**DEFENSE NUCLEAR FACILITIES
SAFETY BOARD**

Staff Issue Report

SUBJECT: Plugging of Process Lines, Pretreatment Facility, Waste Treatment and Immobilization Plant, Hanford Site

Figure A-1. Flow Regimes for Centrifugal Pumps HLP-PMP-00017A/B

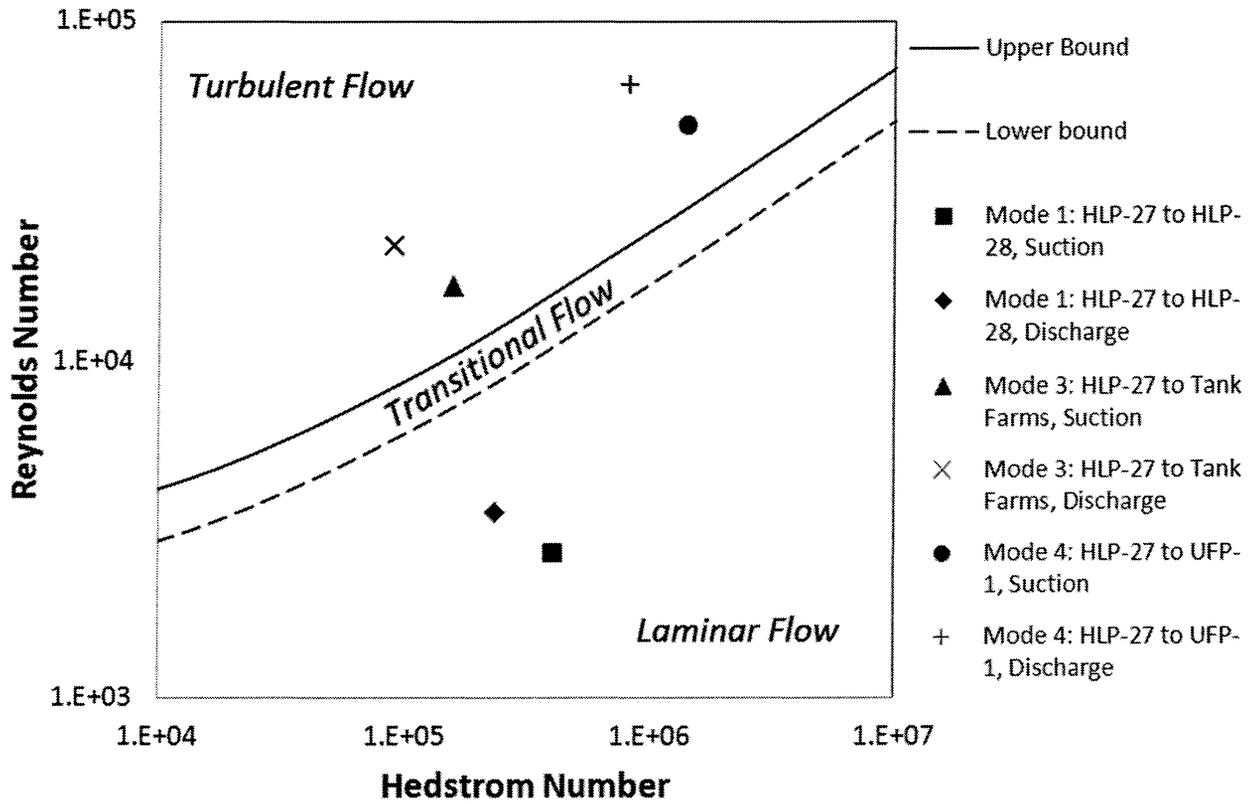
Figures A-1 through A-3 below depict flow regimes for centrifugal pumps at the Pretreatment Facility (PTF) for transferring non-Newtonian slurries (Prado, 2011a, 2011b; Bauer, 2011). These figures show that the current design strategy for non-Newtonian pipelines at PTF will produce laminar or transitional flow in several non-Newtonian process lines, which may lead to pipeline plugging.

Figure B-1. SAR Number for Simulated WTP Process Streams

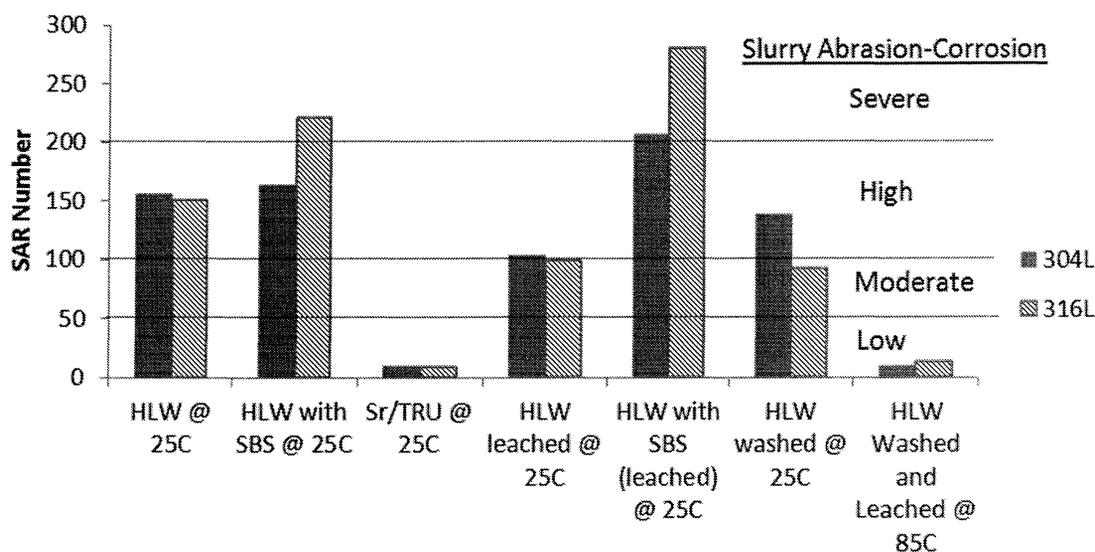
Duignan (2002) produced seven WTP waste stream simulants and performed a standard abrasivity test per ASTM G75-01, *Standard Test Method for Determination of Slurry Abrasivity (Miller Number) and Slurry Abrasion Response of Materials (SAR Number)* (American Society for Testing and Materials, 2001), to determine a Slurry Abrasion Response (SAR) number for two types of stainless steel used by the WTP project, 304L and 316L. The ASTM G75 method uses a Miller number machine to determine the severity of abrasion-corrosion of the slurry on the wear materials by measuring the rate of mass loss from the material specimen and converting these data to a SAR number. During a test, a stainless steel wear block is attached to a reciprocating arm that slides the block at a controlled rate across a trough filled with slurry. Mass loss of the wear block occurs as the bottom of the block abrades from the sliding action of the block, slurry, and bottom of the trough. The ASTM method specifies that the bottom of the trough is made of a standard lap material, neoprene. The block is machined to dimensions specified by the standard and loaded with a total downward force of 22.24 N (5 lb). SAR number results from the seven simulated WTP slurries are shown in Figure B-1 along with a rating scale that shows regions of low to severe abrasion-corrosion. The results indicate that process chemistry, e.g., the addition of the submerged bed scrubber (SBS) solution, plays an important role in abrasion-corrosion of WTP process streams.

BNI's wear calculations assume that the stainless steel piping will experience little erosion at low flow velocities due to the small size and amount of hard waste particles. ASTM G75-07 (American Society for Testing and Materials, 2007) states:
